CITY PLANNING COMMISSION

- APPLICATION:
- A. Negative Declaration
 - B. Lot Line Adjustment to merge two undeveloped parcels
 - C. Plan Review for a six unit apartment complex on 0.3+ acres in the Multi-Family Review [R-3R(EA-4)] zone

LOCATION: 2601 47th Avenue

APPLC. NO. P89-182 MEETING DATE May 25, 1989 ITEM NO. 17

FRONT & REAR ELEVATIONS
Ventura Garden Apartments
Sacramento, Ca.

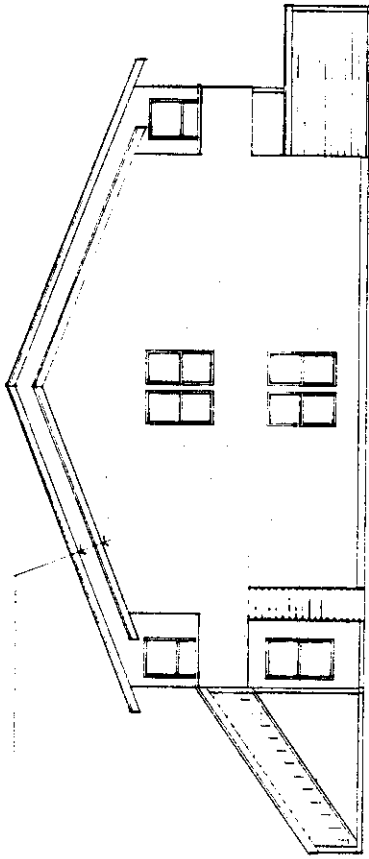
1. The applicant should reverse the building orientation so that the side of unit number 1 is facing Ventura Street and unit 3 is near the parking area. This is to better allow the enhancement of the elevation facing Ventura Street. This enhancement can be achieved by wrapping the second story balconies around facing Ventura Street. Staff also suggests a window be placed on the wall facing the balcony. These balconies can project 2 feet into the front yard setback without requiring a variance.

4. The windows should be trimmed using the standard window trim treatment as shown in Exhibit C.
5. The applicant should provide a raised planter or large shrubs along the stucco walls facing 47th Avenue in order to break up the bare wall.

1. The building orientation shall be reversed so Unit 1 is facing Ventura Street and Unit 3 is near the parking area.
2. The second story balconies shall wrap around the building to the Ventura Street side.
3. The portion of the sidewalk extending from the apartments toward the public right-of-way of 47th Avenue shall be removed.
4. The stairs shall be redesigned so the toe of the stairways points toward the parking lot.

5. The windows shall be trimmed using the standard window trim treatment per Exhibit C.
6. The applicant shall provide a raised planter or large shrubs along the stucco walls facing 47th Avenue.

GROUND FLOOR PLAN
Typical

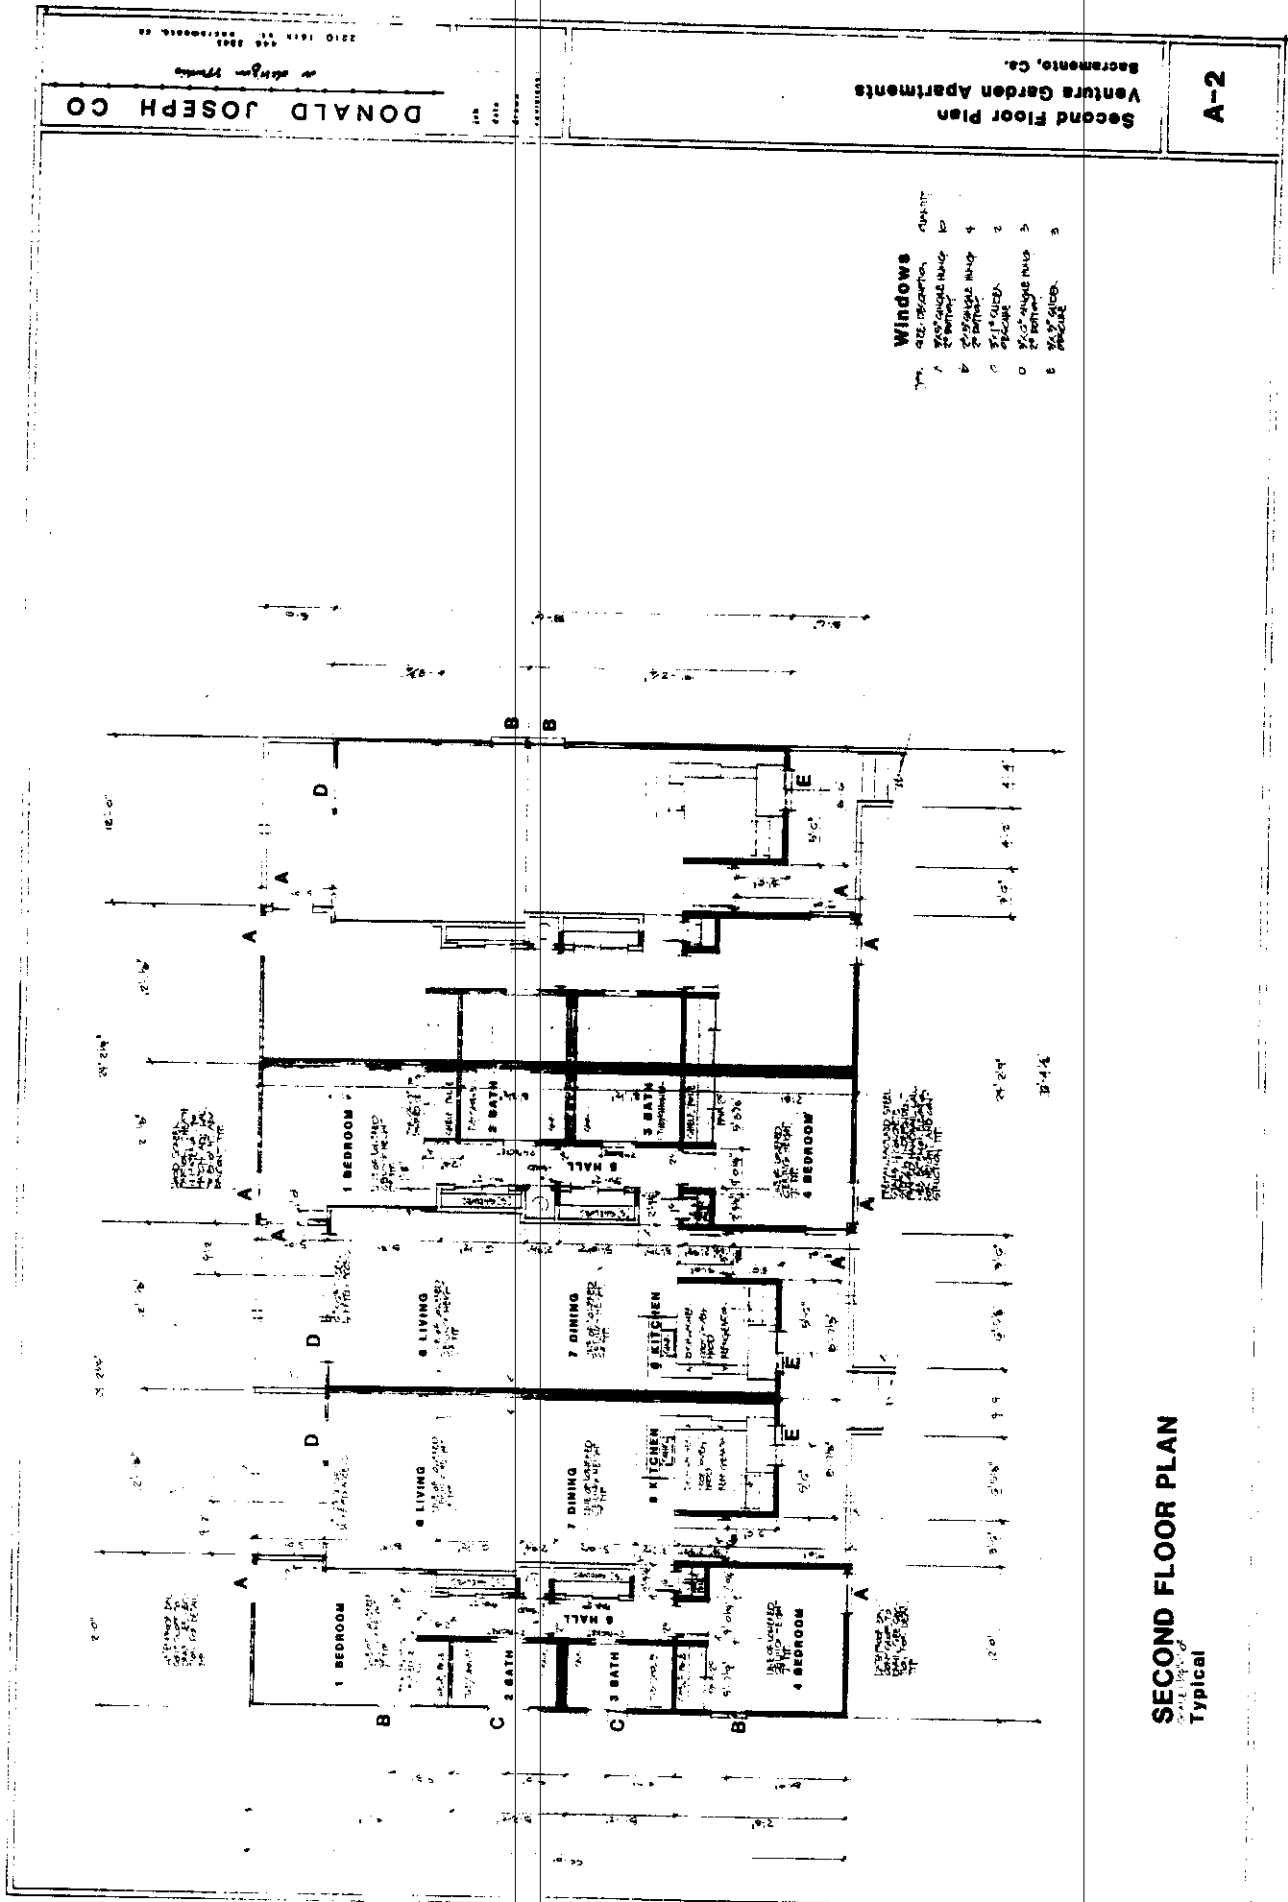
3. Staff suggests the redesign of the stairs with the toe of the stairs directed toward the parking lot such as an L-shaped stairway with an intermediate landing.

SITE PLAN
 SCALE: 1" = 20'-0"

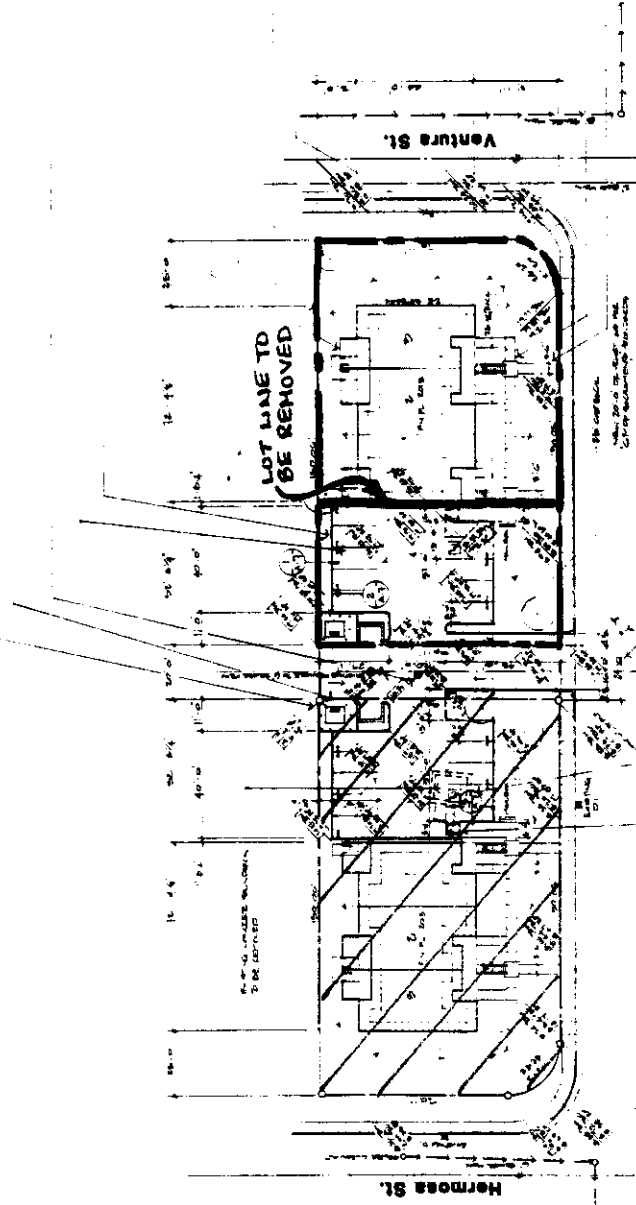
2. The portion of the sidewalk which extends from the apartments toward the public right-of-way of 47th Avenue should be removed to minimize on-street parking.

The six unit apartment complex requires nine parking spaces. The applicant proposes nine spaces located with access from the alley. The parking lot and alley shall be paved to City standards. The alley shall line up with the existing alley and not be offset as shown on proposed site plan.

1. The parking stall directly adjacent to the wall of the building shall be an oversized compact stall in order to allow easier maneuverability.
2. The parking lot should be screened from view from 47th Avenue by a low stucco wall. The wall should look similar to the building and be located directly adjacent to the parking area. There should also be landscaping in front of this wall.
3. The applicant shall also provide a 6 foot solid masonry wall along the property line between the parking area and the adjacent single family residential lot.

The trash enclosure is located with its access off the alley. There needs to be an opening for pedestrian access from the interior of the site and the access gates should not face the alley. The trash enclosure shall be built to the requirements of the Zoning Ordinance.

7. The parking lot and alley shall be paved to City standards.
8. The alley shall line up with the existing right-of-way. The full right-of-way shall be improved, with no obstructions, to the satisfaction of the Public Works Department.

9. The parking lot shall be screened from view by a low stucco wall similar to the building.
10. The applicant shall provide a 6 foot masonry wall along the property line between the parking area and the adjacent single family lot.

13. A detailed landscape plan shall be submitted to the Planning Director for review and approval prior to issuance of building permit.
14. The trash enclosure shall have an opening for pedestrian access and be built to the requirements of the Zoning Ordinance. Access gates shall not open into the alley.
